INSPECTION OF MECHANICAL FEATURES

**Helmand Valley
Development Project**

AFGHANISTAN

May 1964

KAJAKAI DAM
AFGHANISTAN
HOLLOW-JET VALVE INSTALLATION

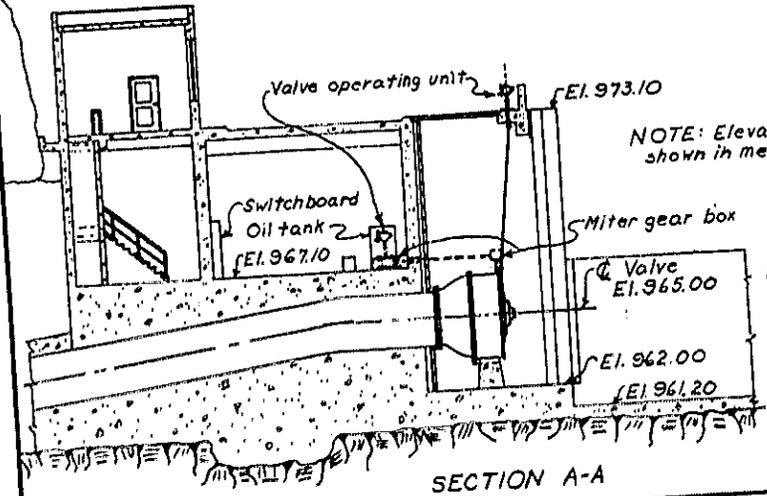
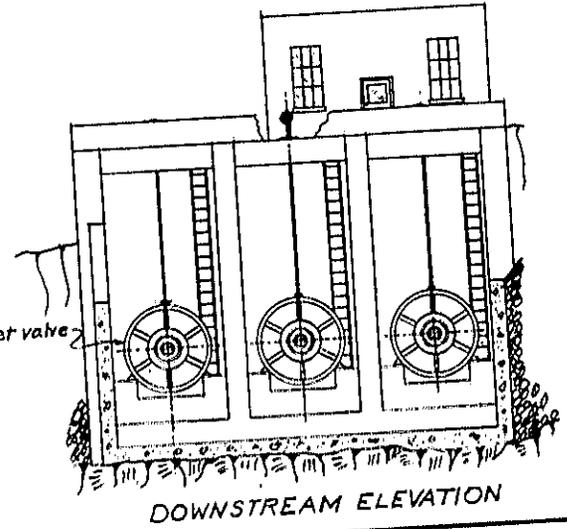
3. The electric control instruments (Figure 7) including the pushbuttons, selector switch, indicating lights and indicator for each hollow-jet valve should be moved from the present control board to a small panel located on the wall adjacent to the hydraulic controls. This will give the operator a more convenient control system. The installation of an ammeter on the control panel for the gear unit motor would aid the operator in the operation of the hollow-jet valves. To give the operator better access to the hollow-jet valve controls, the valve operating unit should be moved into the control house. The shaft could be passed through a packing gland in a sleeve through the wall of the control house. Shaft connections between the hollow-jet valve and valve operating unit could be made with two sets of miter gear as shown on Drawing No. 3.

Figure 18. --Girishk Powerplant Unit 2
turbine runner. Edges of blades show
wear from dragging on the lower
crown ring.

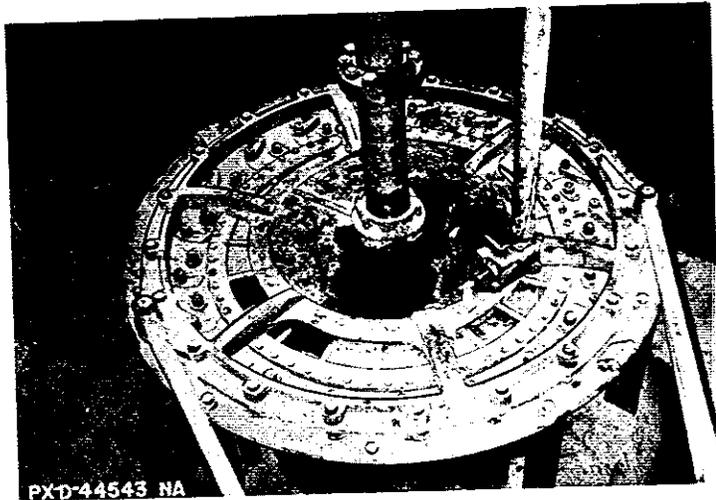
The generator shaft was found to be plumb. The turbine shaft had been partially re-assembled and would have required disassembly to take accurate measurements. However, measurements were taken of the clearance between the turbine shaft and guide-bearing housing (with the bearing out) with a 12-inch-long feeler gage. These measurements disclose an offset of the bearing bracket in relation to the turbine shaft of approximately 0.022 inch. Evidence shows that an effort had been made to aline the shaft by machining the guide-bearing bracket and shifting it to correct for alinement. Measurements that are possible to take without a complete disassembly show that the shaft still remains approximately .008 inch out of alinement. As a result of the guide-bearing bracket being shifted in the turbine housing, the runner blades (Figure 18) show evidence of dragging on the lower crown ring.

Figure 19. --Girishk Powerplant Unit 2.
Turbine runner blade shows evidence
of severe dragging between the edge
of the blade and lower crown ring.

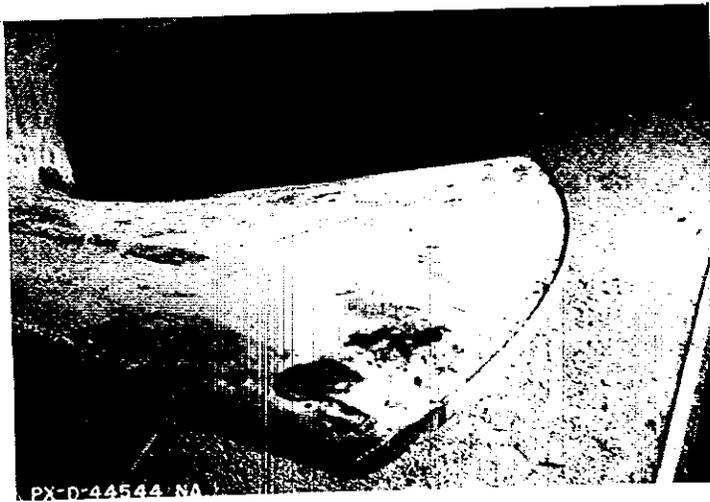
Outside edges of the rotor blades (Figure 19) have worn flat and the edges have curled out beyond the thickness of the blades. The turbine shaft (Figure 20) and turbine shaft bearing were found badly grooved and worn. The lower crown ring was found 0.4 inch (1 centimeter) out of level. The shaft coupling had been shimmed with wedge-shaped shims so that the bolts could be tightened without leaving a gap at the coupling joint. The two shaft flanges do not appear to be parallel. The space between the turbine wicket gates, in the closed position, varied from .002 to .110 inch from top to bottom on some of the gates. Enough water leaked past the wicket gates to prevent the turbine from stopping without heavy application of the brake. The governor shaft that extends below the generator and operates the wicket gates was approximately 1.5 inches out of plumb and a support bracket was found broken. A new bracket has been installed and alinement has been corrected. The turbine is designed for a wicket gate opening of 10.5 inches (26.7 centimeters). The maximum opening that can be obtained with the present linkage on the governor shaft is 9.125 inches (23.2 centimeters).

Figure 22. --Girishk Powerplant Unit 1. The turbine shaft bearing bracket assembled on the floor to measure the bearing diameter.

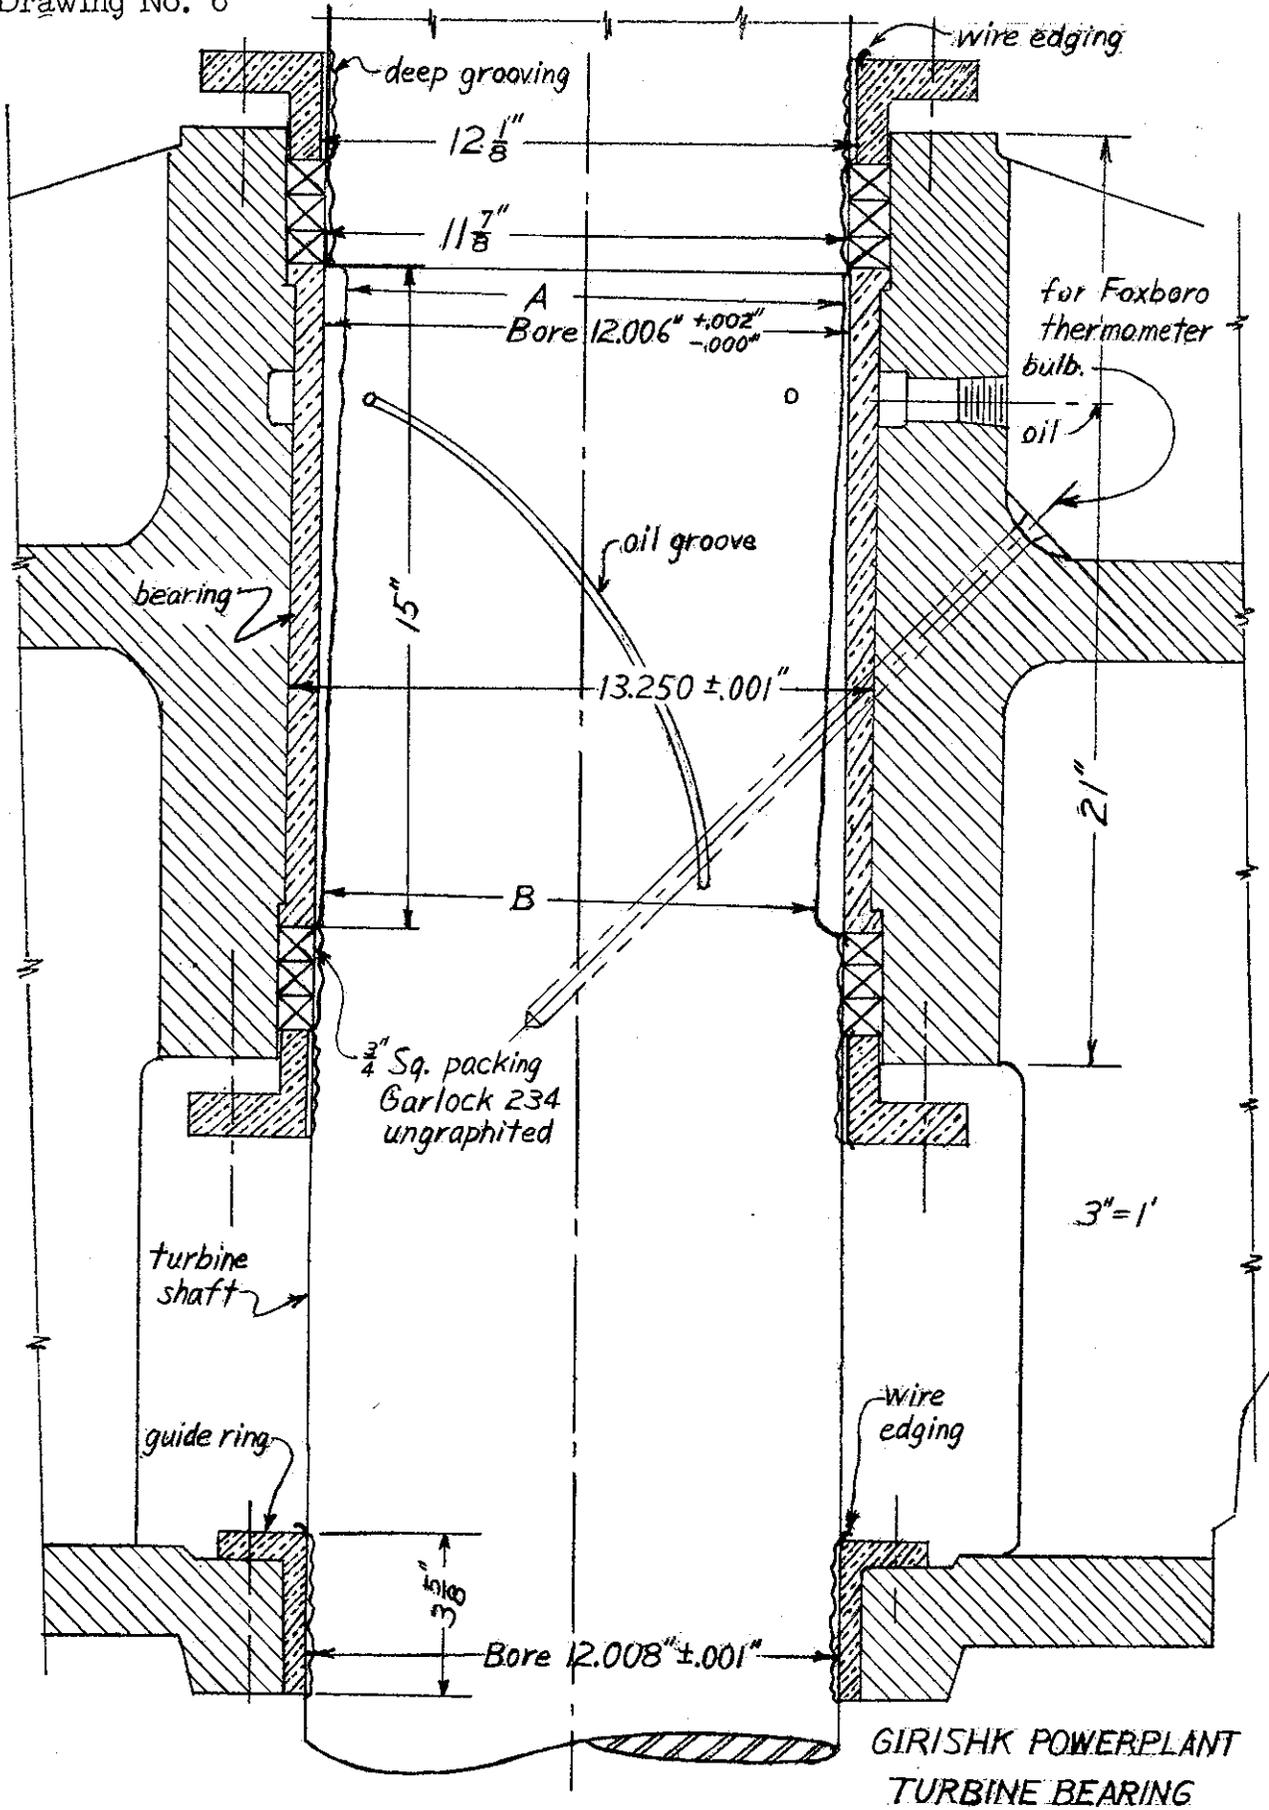
Shimming in sizes up to 3/8 inch was found under the legs of the turbine bearing bracket (Figure 22) and the holes for the bolts that fasten the bearing bracket to the turbine were enlarged from 1 9/16 inch, as shown on the drawing, to 2 1/8 inch as shown in Figure 23. The space between the 1 1/2 inch bolt and the hole had been filled with lead.

Figure 25.--Girishk Powerplant Unit 1. Turbine shaft bearing area showing severe worn surfaces. Area between 2 and 5 is the main bearing area.

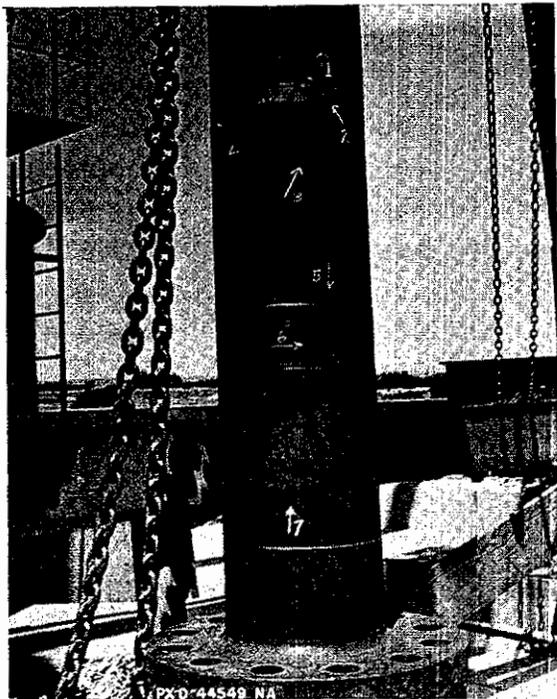
5. A visual inspection of the shaft showed severe wear over the entire bearing area. Apparently, most of the wearing had been done before the present bearing was installed as the bearing showed little wear. The turbine shaft measured 0.120 inch flat at Point A - (Drawing No. 6). From Point A, the shaft tapers at an angle to the centerline 0.124 inch to Point B. This makes the shaft a total of 0.244 inch undersize at Point B.

Figure 31. --Boghra Canal Wasteway. The notch-type clutch is used to change from manual to automatic control of the wasteway gates.

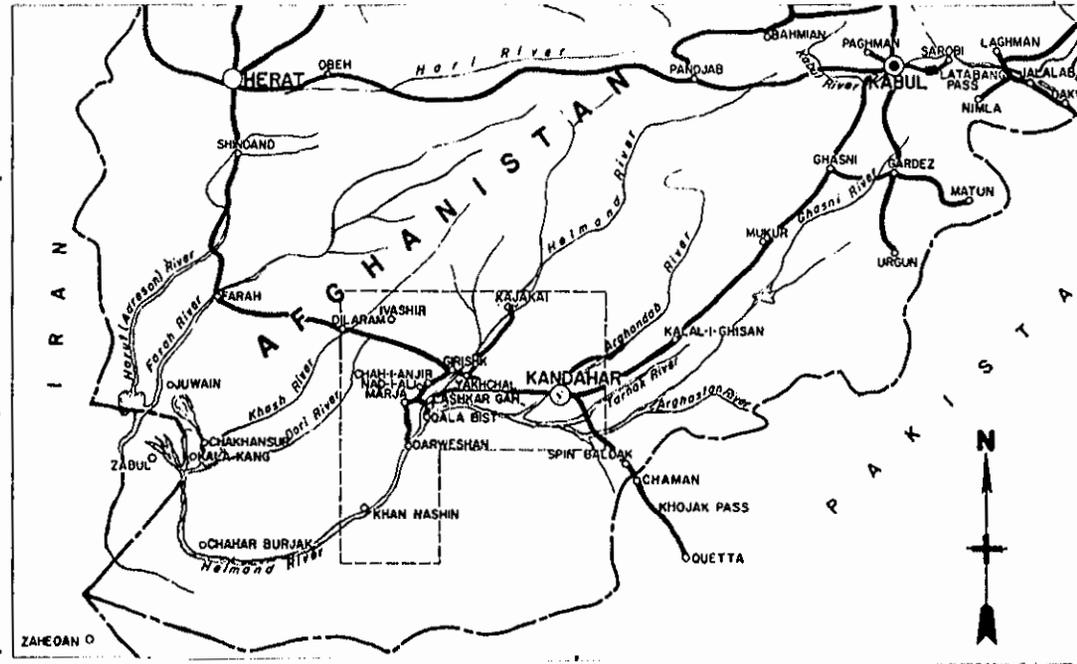
not go down. After prying the weight loose from the guides and dislodging the rope drum shaft from its bearings with a bar, the automatic mechanism began to work, but very sluggishly. The clutch (Figure 31) on the end of the rope drum shaft which should slide freely by hand could not be shifted even by forcing it with a bar. In examining the shaft it was found that lack of greasing and accumulation of dirt, grit and hardened grease had bound the bearings to the shaft so tight that it required tremendous force to turn it.

1. Remove all bearing covers from the wire rope drum shafts, clean bearings and shaft bearing surface with kerosene or some suitable solvent that will remove the dried grease and dirt. Smooth bearing surfaces, if necessary, and reassemble.
2. Check to see that all grease holes in bearings are open, replace missing grease fittings, and grease all shaft bearings once a month during irrigation season.
3. Make sure that wire ropes on each gate have equal tension and are securely anchored both on the gate, and on the drum.
4. Clean all open gears of hoist mechanism and operate gears dry. Grease when mixed with sand is more harmful to gear than no grease at all.
5. All tainter gates and metalwork should be examined once a year for deteriorated or damaged paint. Paint repairs or repainting, if needed, should be done immediately.

Figure 34.--Boghra Canal Waste-way. Approach to gate structure bridge has separated 2 to 4 inches at the joint on the first pier.

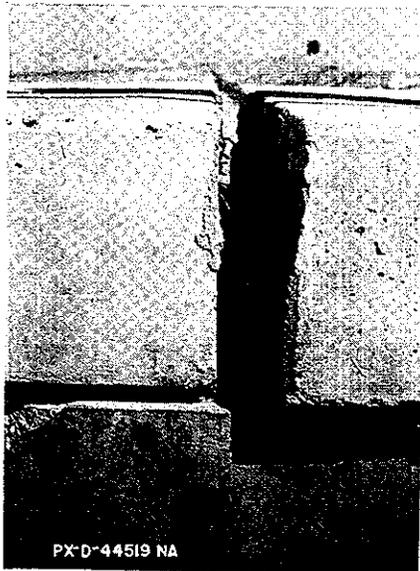
The concrete approaches at both ends of the concrete bridge over the gate structure have separated 2 to 4 inches (Figure 34) at the joint of the first pier on both sides of the canal. This appears to have occurred from settling of the canal bank as the main structure does not show any faults or cracks.

TAINTER GATE
LOWER BEAM MODIFICATION

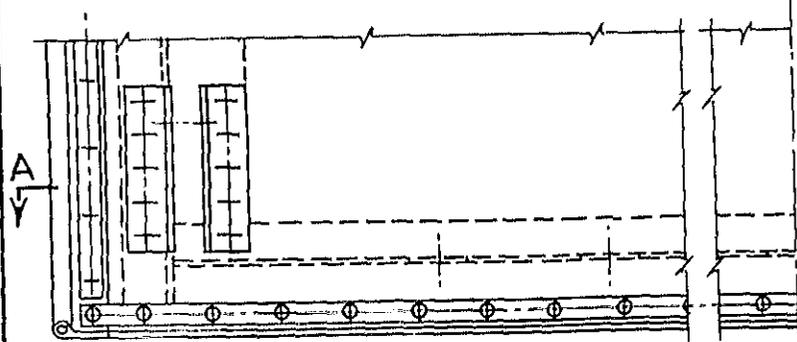
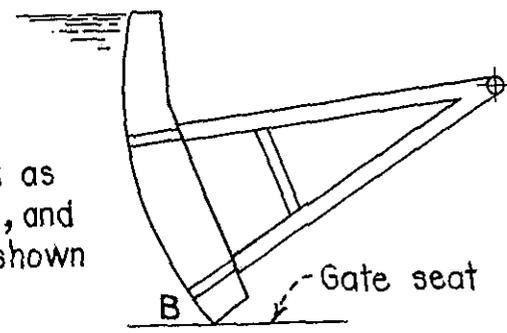
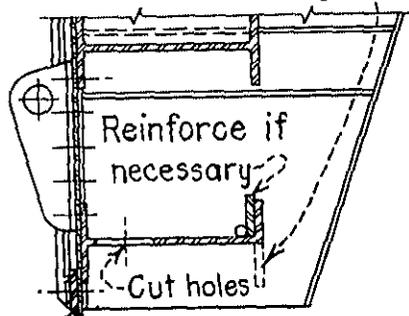
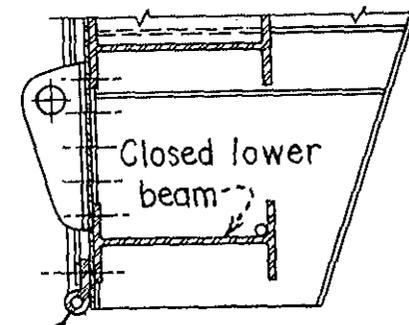
2. Vibration of tainter gates results from fluctuating pressures under the bottom seals and beams when the tailwater is above the lower beam. Fluctuating pressures can result when music note seals or closed beams are used across the bottom of the gate as shown in Detail B2, Drawing No. 9.

Vibration may be minimized or eliminated by replacing the music note seals with a flat rubber seal, by cutting holes through the web of the lower beam, and by cutting off the lower half of the downstream flange of the bottom beam. See Detail B1, Drawing No. 9, noting flange reinforcement.

If gate is constructed as shown on Detail B₂, and if vibrates, modify as shown on Detail B₁.

Cut off lower downstream leg:

Replace music note seal with flat rubber seal.
